Staff Summary Report

Development Review Commission Date: 08/14/07

SUBJECT: Hold a public hearing for a Zoning Map Amendment and a Development Plan Review for **CAMPUS TOWERS** located at 1215 East Orange Street.

DOCUMENT NAME: DRCr_Campus-Towers_081407

S-1001
 SHEET NO.

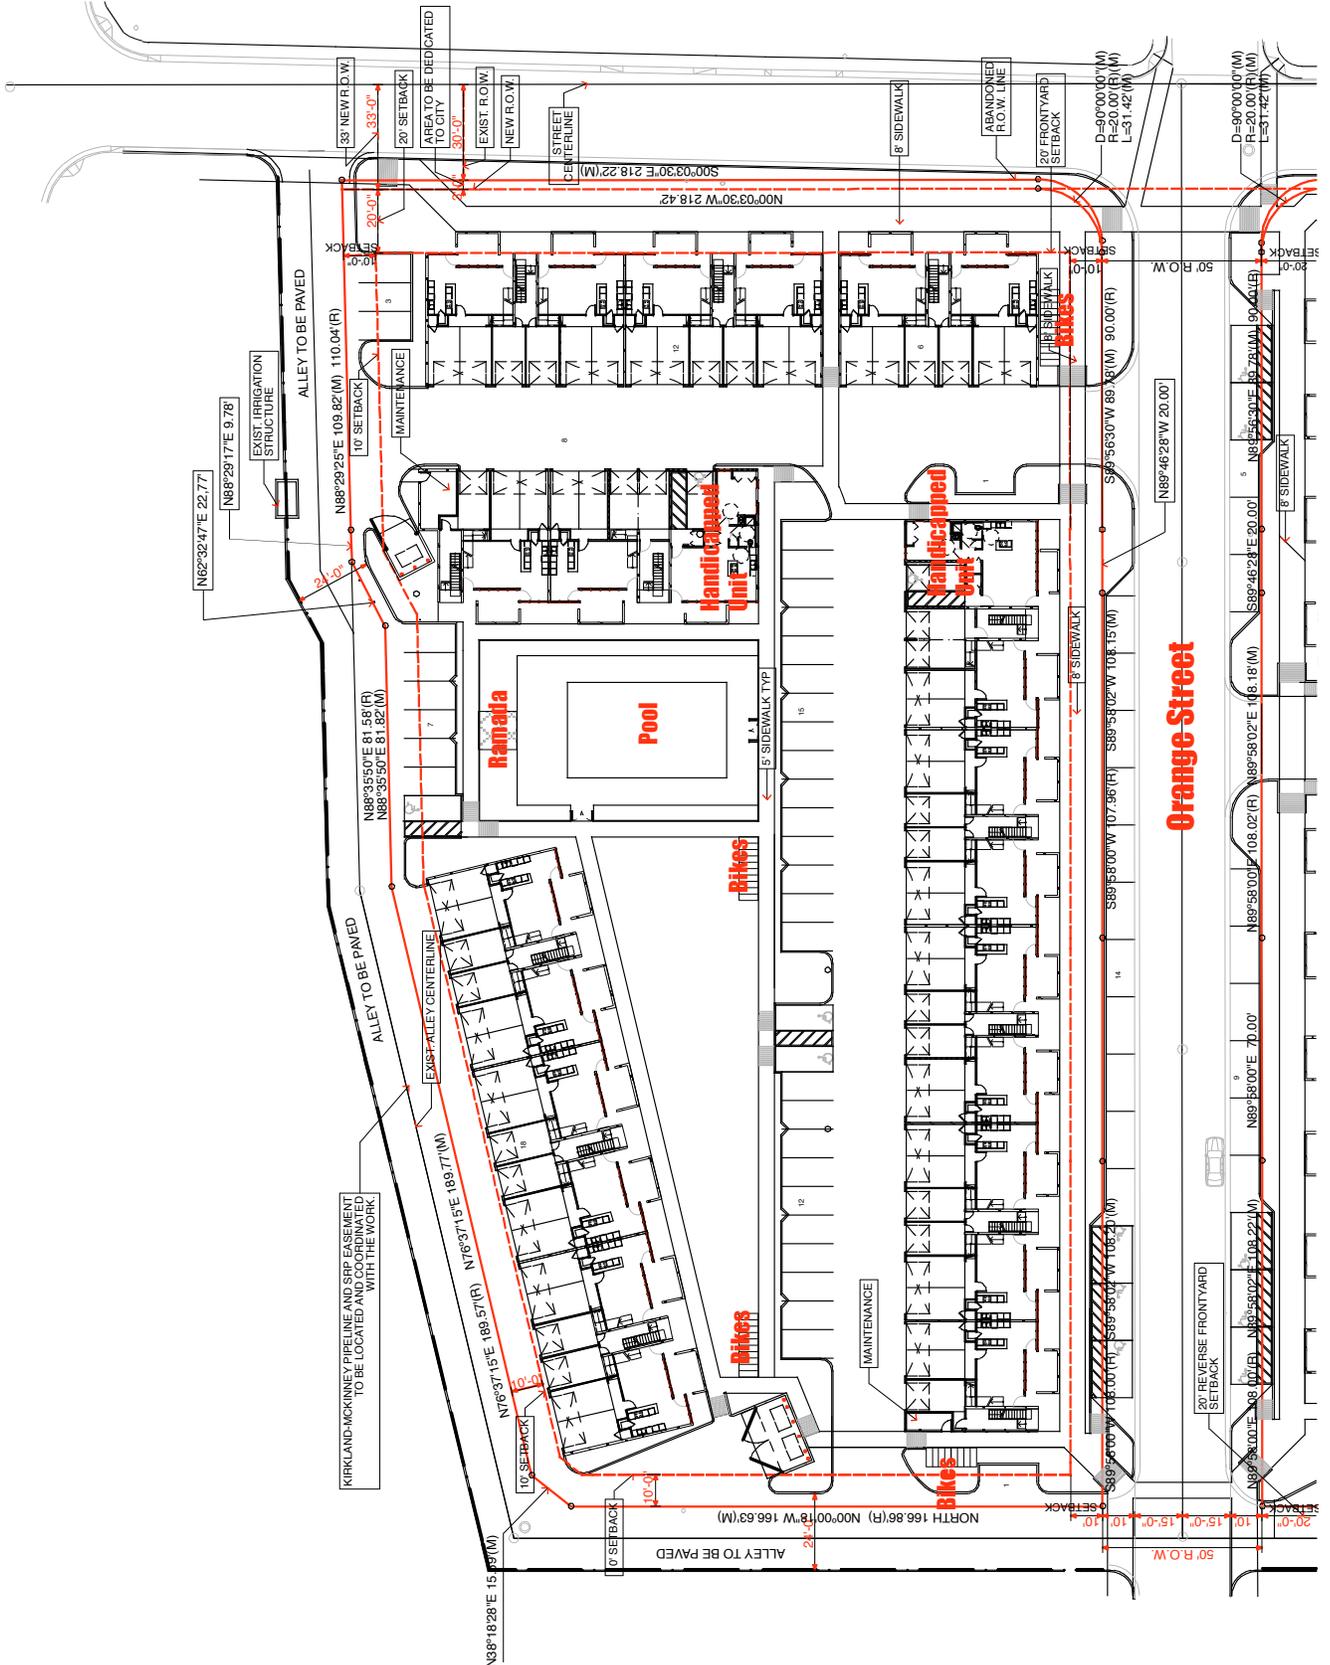
16. Provide upgraded paving at each driveway apron consisting of clay or concrete unit paving. Extend unit paving in each driveway from the back of the accessible public sidewalk concrete bypass to 20'-0" on site and from curb to curb at the drive edges.

- Provide parallel parking spaces that are minimum 8’-6” wide by 22’-0” long. Reduce quantity of parallel parking spaces to accommodate this width and modify parking calculation accordingly.

28. Provide additional canopy trees throughout development. Refer to Site Plan Review mark-up, dated 6/20/07, for graphic description of this requirement. In particular, provide required parking landscape island canopy trees in all locations, provide canopy trees along west of Dorsey and on both sides of Orange, and provide a canopy tree row on the north side of the Parcel A triangular green.

S-1002
 SHEET NO.

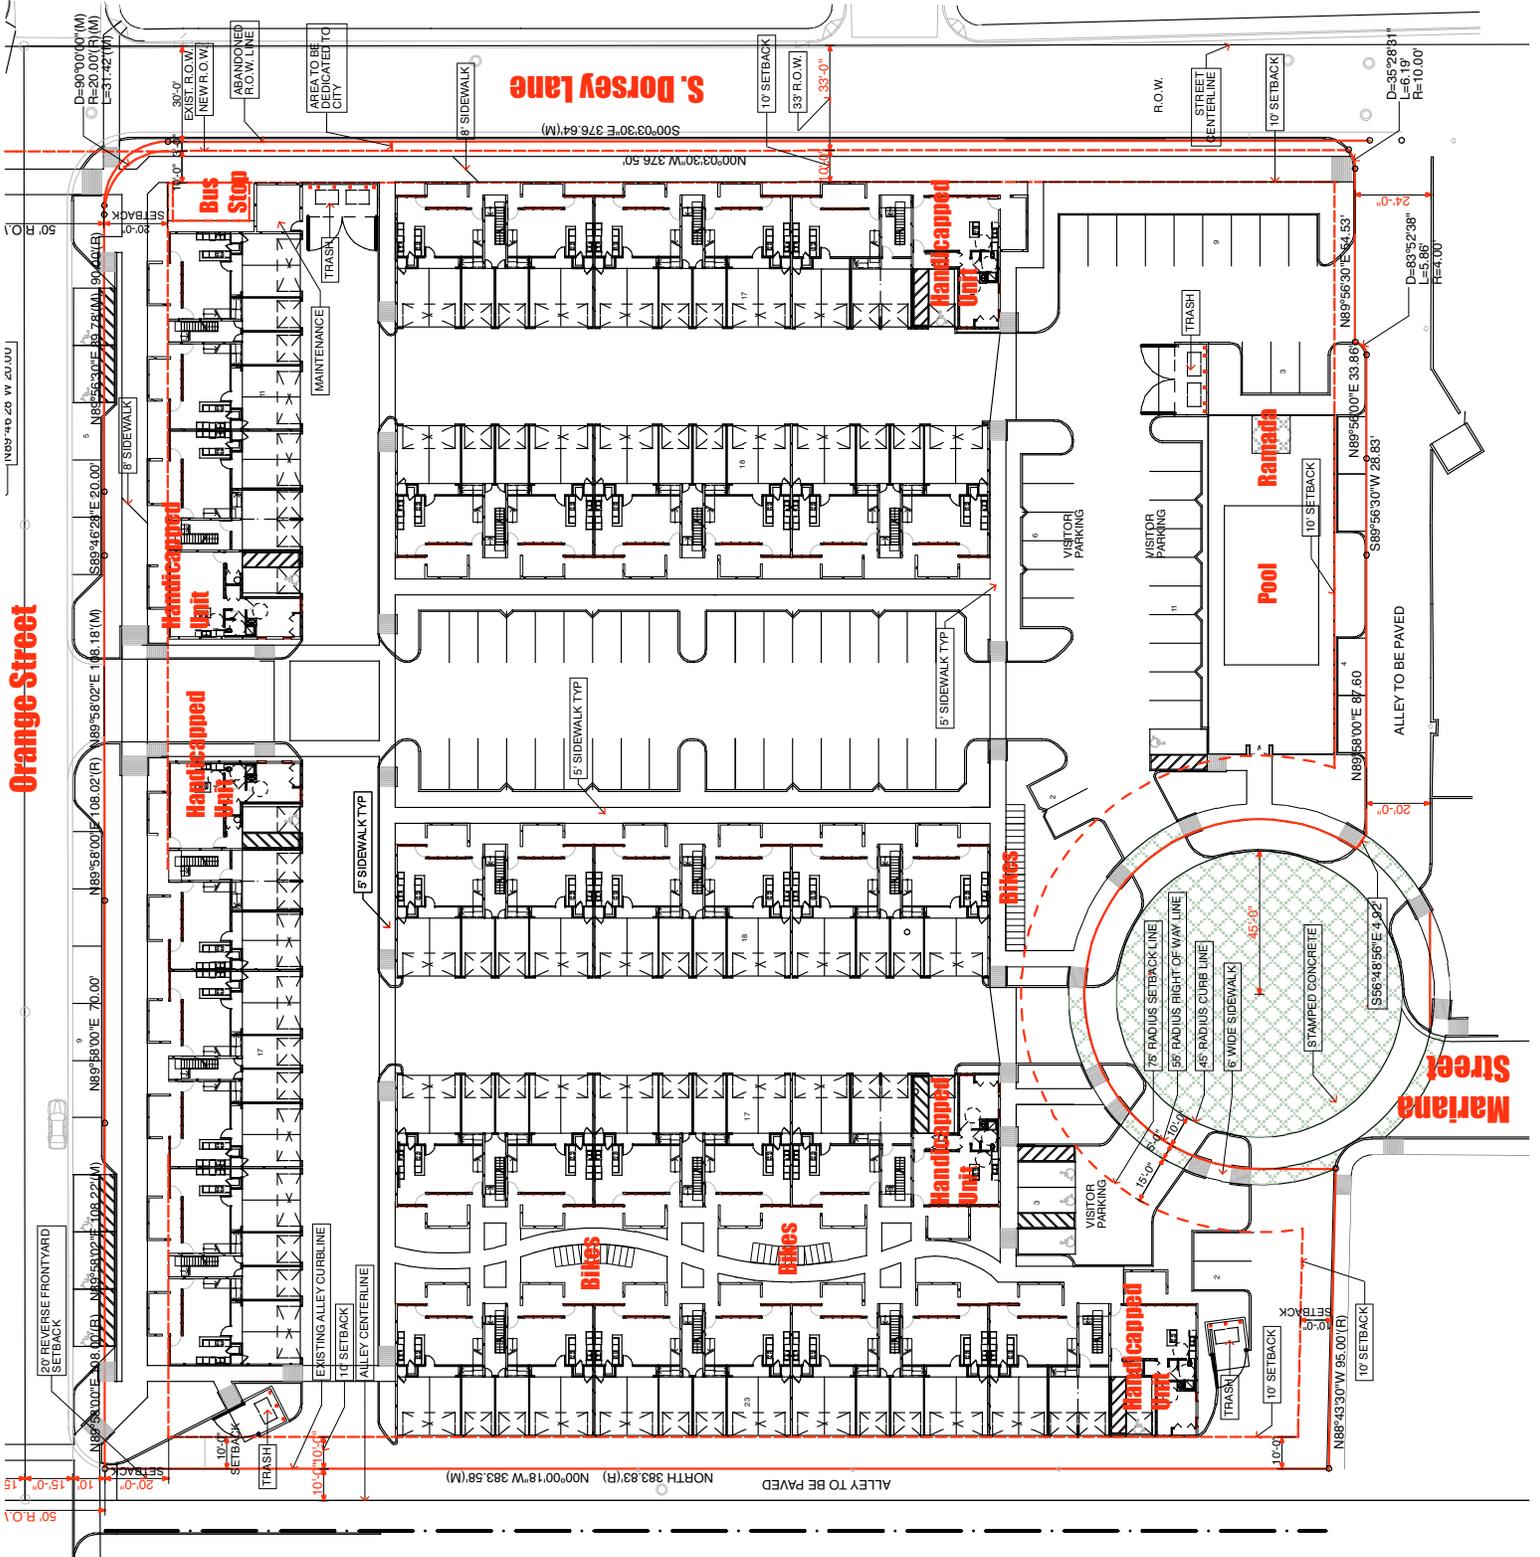
` In post-meeting discussion, the architect & Planning Division staff reviewed site plan & determined the south parcel layout can be modified to create a 20' building setback on Dorsey. This setback would be measured from the dedicated right of way line, which is 3' west of the current property line. The increased setback will push the 34' high building facade approximately 6' farther west of where it is now & will allow more room for a landscape buffer.

17. Provide upgraded cast in place design scored concrete paving at Mariana cul-de-sac in conformance with Engineering Division / Public Works standard.

- 100 year storm water retention is required on-site for each parcel. Do not drain runoff into adjacent streets. Re-configure sub-surface retention structures so they are not under parking landscape islands and interfere with required tree planting locations. Planning Division staff recommends use of grassy retention basins as filters for storm water, potentially allowing use of single chamber drywells. Determine requirements for the design of the parcels with the Public Works Department, Engineering Division (ken_halloran@tempe.gov).

The significant change is that the applicant has determined that it is possible to increase the building setback along the entire length of Dorsey Lane to 20 feet. As you may recall, during the neighborhood meeting a suggestion was made that both the northerly and southerly parcels maintain the 20 foot setback. After the meeting and upon further review the applicant has determined that a 20 foot setback is possible. As a result, when this case goes to the Development Review Commission on August 14th, the City of Tempe staff will propose a 20 foot setback along the length of Dorsey Lane and the applicant will agree with that stipulation.

S-1011
 SHEET NO.

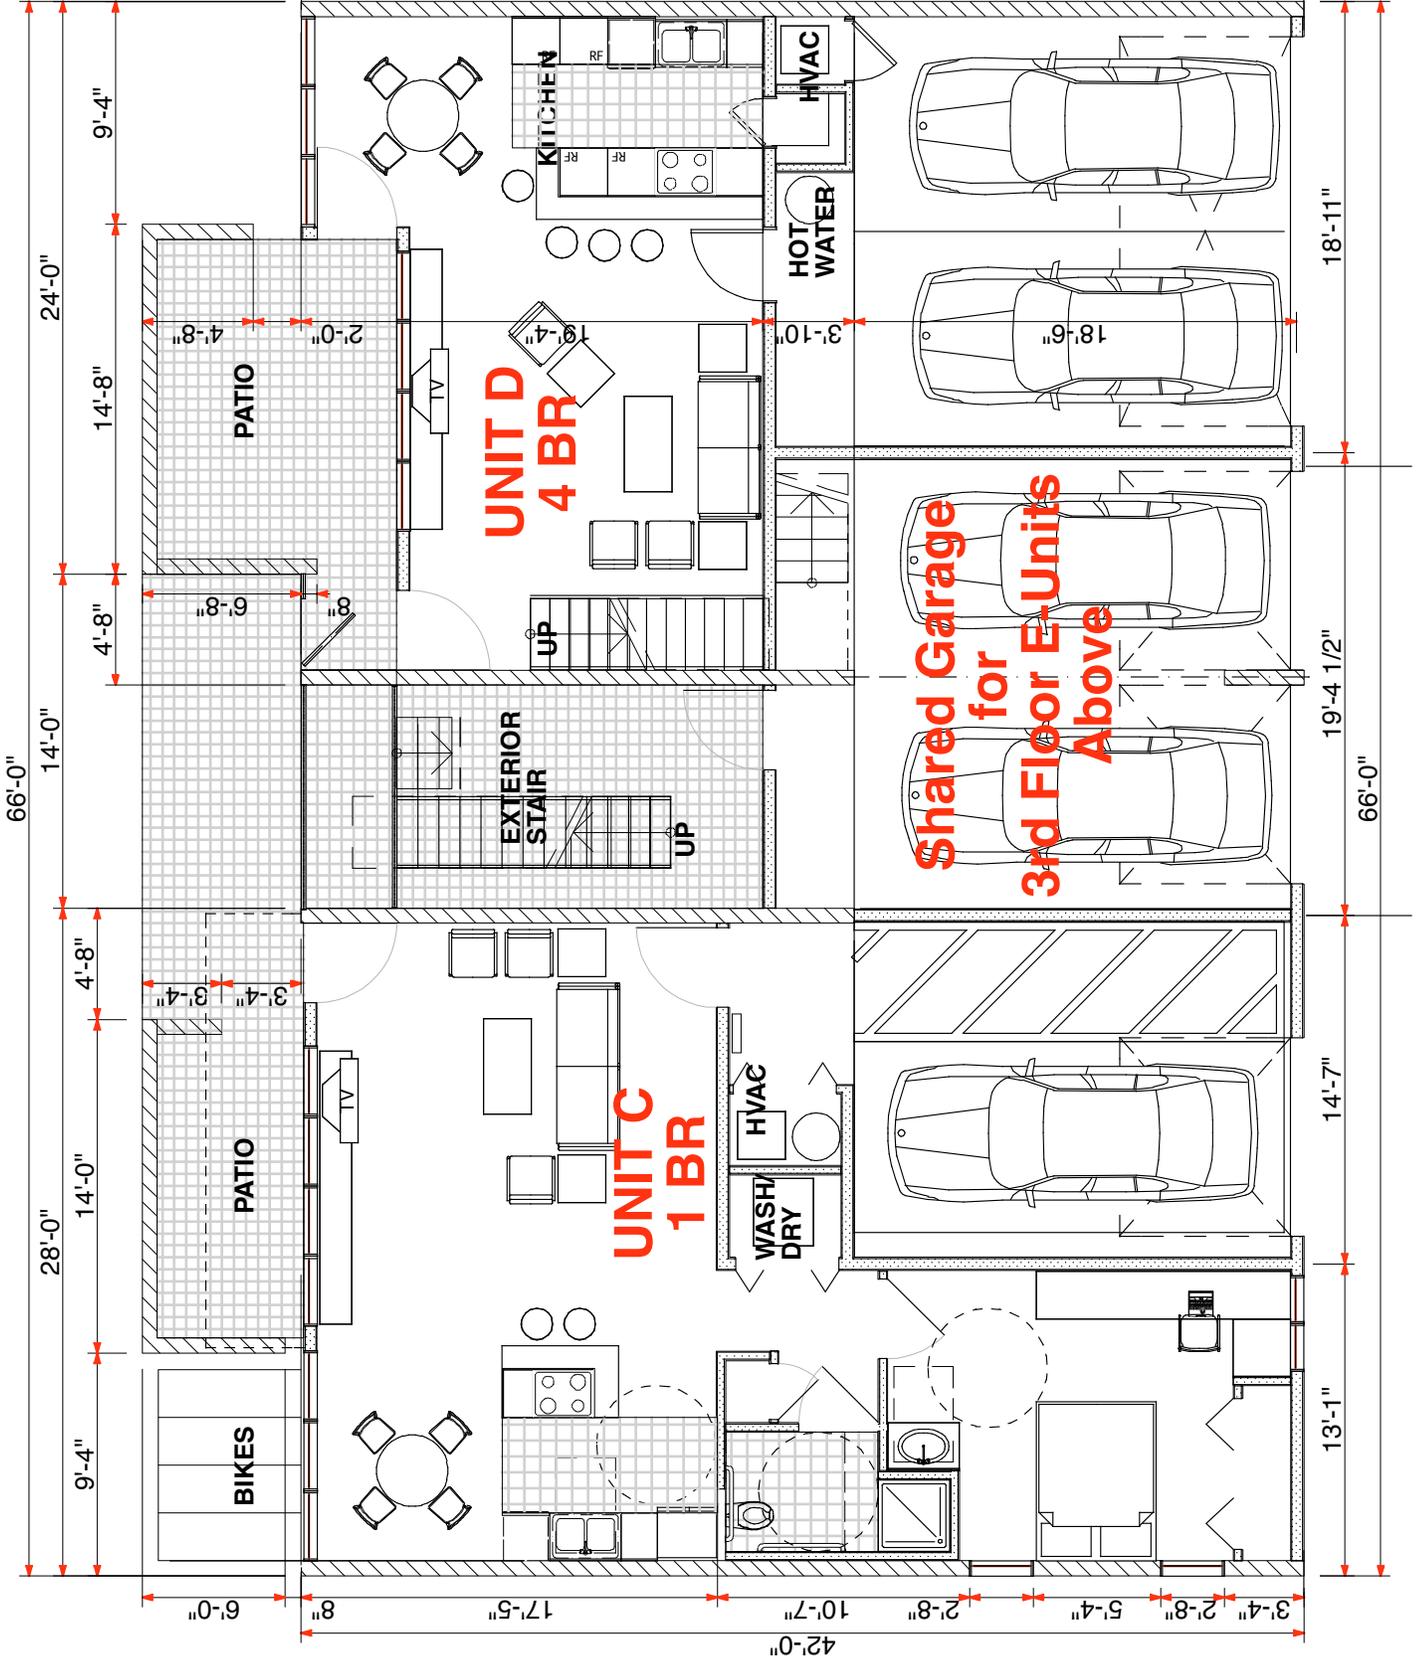
- a. Widen garage door for Dwelling Unit C, typical, to include width of side aisle as well as car space for disabled parking.
 - b. In all unit garages, paint interior wall and overhead surfaces with a highly reflective white color using paint with a minimum light reflectance value of 75 percent.
- Provide a security vision panel at unglazed doors, including at service doors and dwelling entrances (except to rarely accessed equipment rooms). Provide vision panel of high strength plastic or laminated glass, 3" wide, and of height that satisfies the requirement of the Americans with Disabilities Act (allow vertical slot window for viewing from a standing or sitting position). Where a vision panel is not desired, equip door with two 360 degree viewers (one for standing, one for sitting) and mount viewers in accordance with A.D.A. provisions.

ATTACHMENT 28

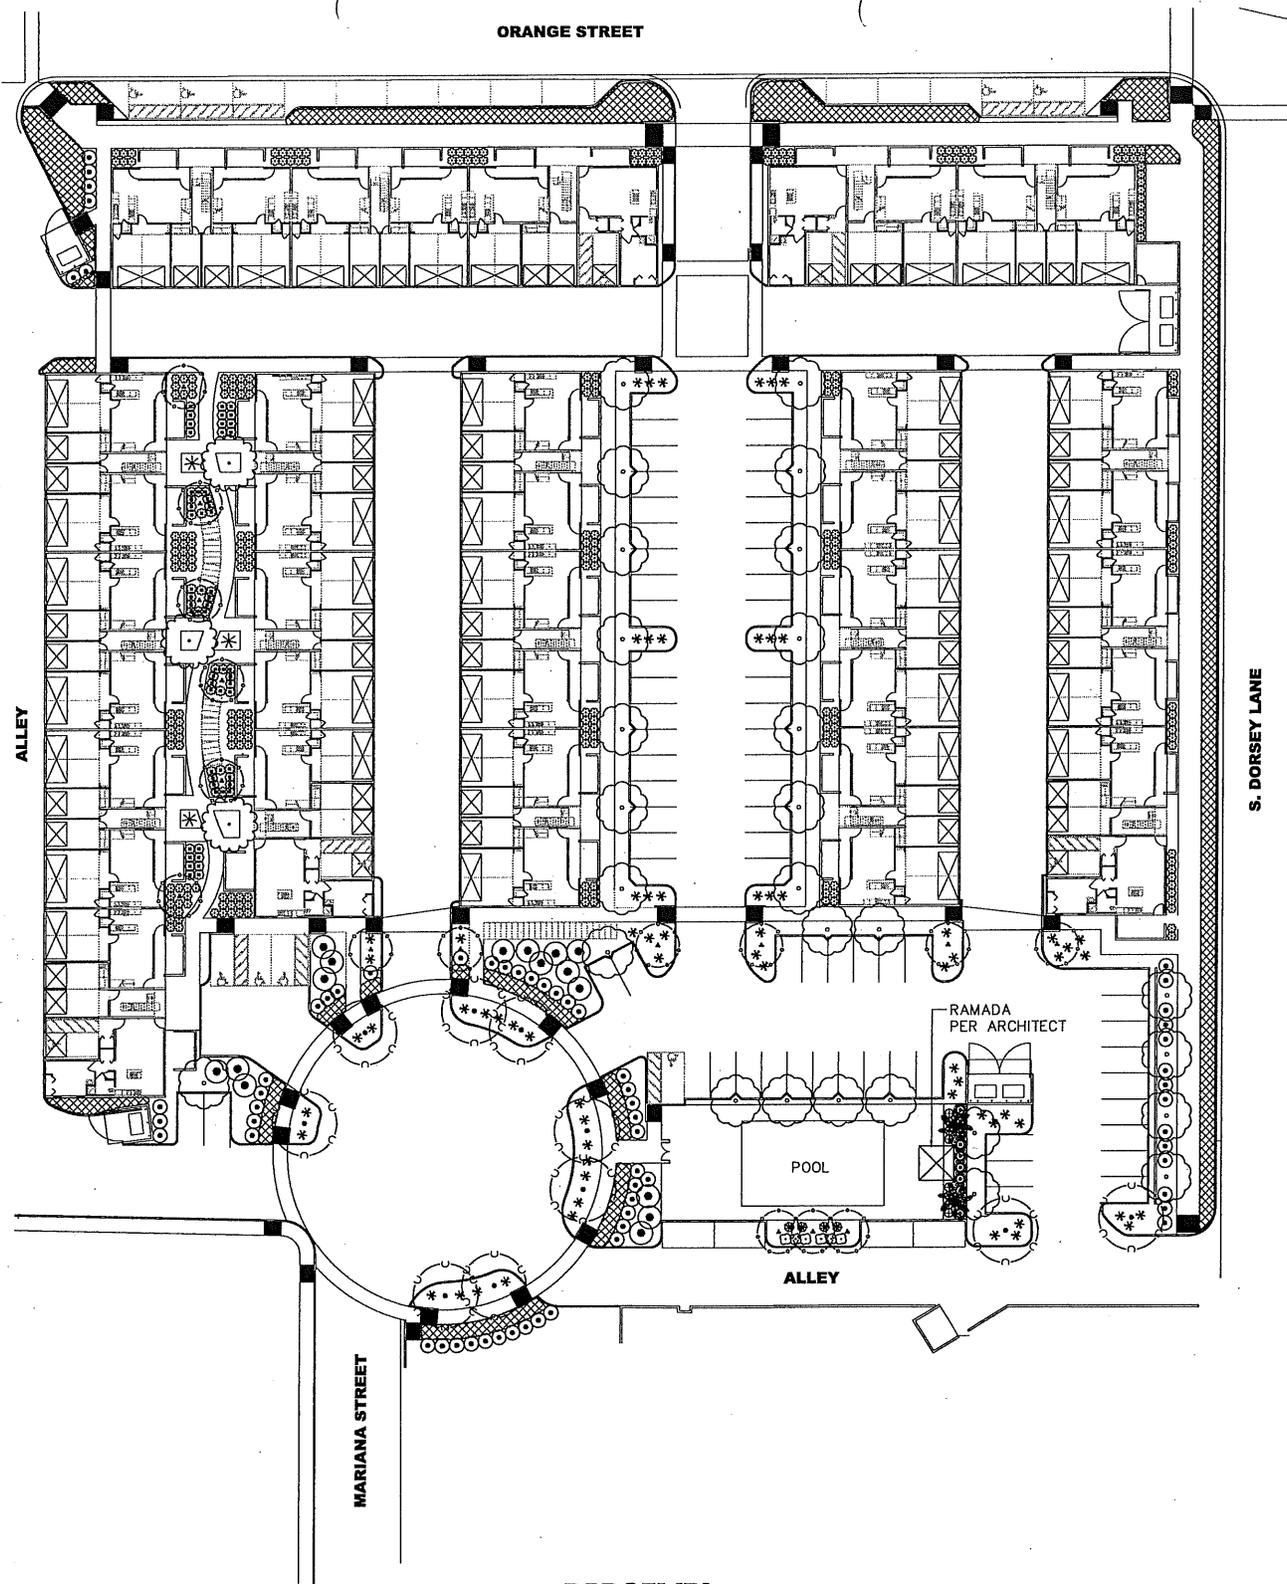
31. Provide trees of minimum 24" box installation size in lieu of 15 gallon size indicated in the plant legend.
32. The following tree substitutions are required: *Parkinsonia* 'Desert Museum' for *Parkinsonia floridum*; and *Phoenix dactylifera* (minimum 20' brown trunk, diamond cut) for *Chamaerops humilis*. Consider salvage of existing *Phoenix dactylifera* in project area prior to site demolition and reuse of these trees in Campus Towers.
